SUBJECT: Initial Draft of MIL-DTL-83503/21 amendment 1, Connectors, Electrical, Flat Cable, Nonenvironmental, Straight Thru (.100 inch spacing) with Polarizing Feature, Solderless Wrappost or PWB Termination, Project number 5935-4771-000.

MIL-DTL-83503/21D
w/AMENDMENT 1
DRAFT
SUPERSEDING
MIL-DTL-83503/21D
21 July 2004

CONNECTORS, ELECTRICAL, FLAT CABLE, NONENVIRONMENTAL,
HEADER, STRAIGHT THRU (.100 INCH SPACING) WITH POLARIZING FEATURE,
SOLDERLESS WRAPPOST OR PWB TERMINATION

FIGURE 1. Dimensions and configuration.

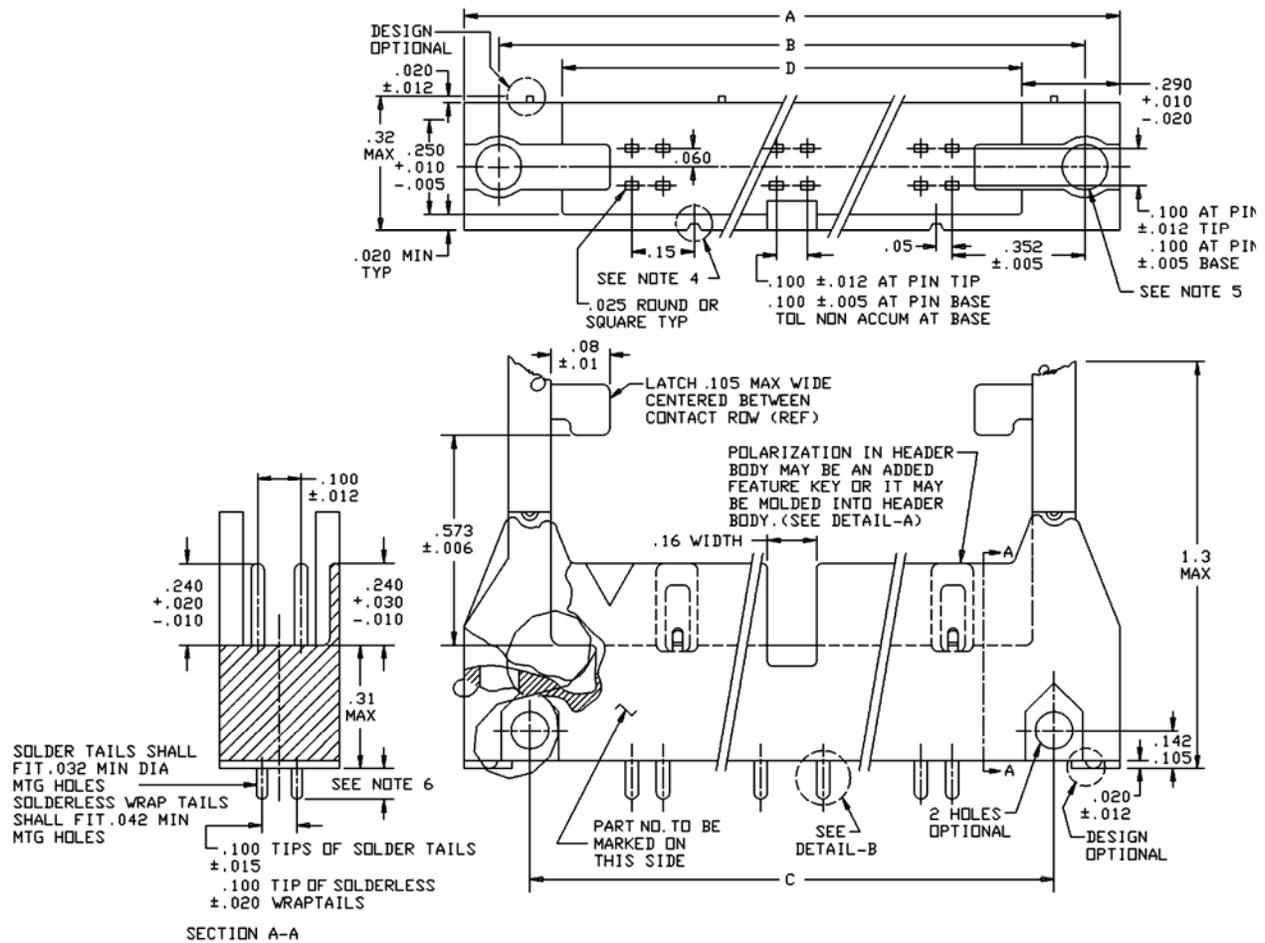
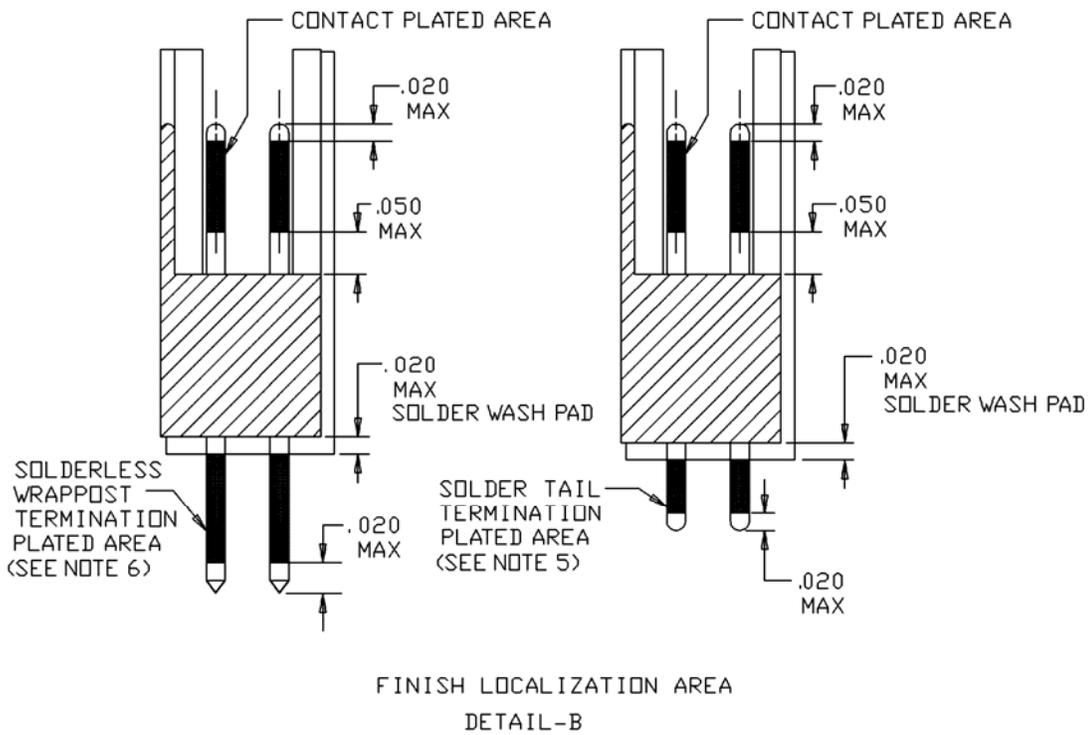
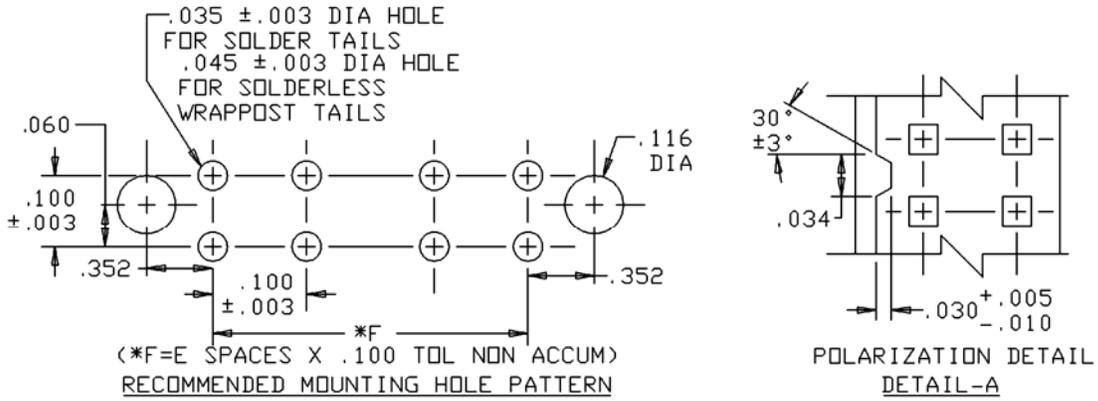
Major changes to this document are on page 4, table I. Dimension D has been changed on the following dash numbers:

Dash 16-18 was 2.06, changed to 1.890 (48.01)
Dash 19-21 was 2.36, changed to 2.190 (55.63)
Dash 22-24 was 2.86, changed to 2.690 (68.33)
Dash 25-27 was 3.36, changed to 3.190 (81.03)

Dash Number	Number of pins	Dimensions						Termination, right angle contact type
		A inch (mm)	B inch (mm)	C inch (mm)	D ^{1/} inch (mm)	E spaces	F inch (mm)	
-01	10							
-02	10	1.26	1.10	.86	.690	4	.400	.062 PWB
-03	10	(32.0)	(27.9)	(21.84)	(17.53)		(10.16)	.125 PWB Wrappost
-04	14							
-05	14	1.46	1.30	1.06	.890	6	.600	.062 PWB
-06	14	(37.1)	(33.0)	(26.92)	(21.34)		(15.24)	.125 PWB Wrappost
-07	16							
-08	16	1.56	1.40	1.16	.990	7	.700	.062 PWB
-09	16	(39.6)	(35.6)	(29.46)	(25.15)		(17.78)	.125 PWB Wrappost
-10	20							
-11	20	1.76	1.60	1.36	1.190	9	.900	.062 PWB
-12	20	(44.7)	(40.6)	(34.54)	(30.23)		(22.86)	.125 PWB Wrappost
-13	26							
-14	26	2.06	1.90	1.66	1.490	12	1.200	.062 PWB
-15	26	(52.3)	(48.3)	(42.16)	(37.85)		(30.48)	.125 PWB Wrappost
-16	34							
-17	34	2.46	2.30	2.06	1.890	16	1.600	.062 PWB
-18	34	(62.5)	(58.4)	(52.32)	(48.01)		(40.64)	.125 PWB Wrappost
-19	40							
-20	40	2.76	2.60	2.36	2.190	19	1.900	.062 PWB

-21	40	(70.1)	(66.0)	(59.94)	(55.63)		(48.26)	.125 PWB Wrappost
-22	50							
-23	50	3.26	3.10	2.86	2.690	24	2.400	.062 PWB
-24	50	(82.8)	(78.7)	(72.64)	(68.33)		(60.96)	.125 PWB Wrappost
-25	60							
-26	60	3.76	3.60	3.36	3.190	29	2.900	.062 PWB
-27	60	(95.5)	(91.4)	(85.34)	(81.03)		(73.66)	.125 PWB Wrappost
-28	64							
-29	64	3.96	3.80	3.56	3.390	31	3.100	.062 PWB
-30	64	(100.6)	(96.5)	(90.42)	(86.11)		(78.74)	.125 PWB Wrappost

^{1/} Tolerance for "D" dimension is +.030 -.000 inch (+0.76 -0.00 mm).
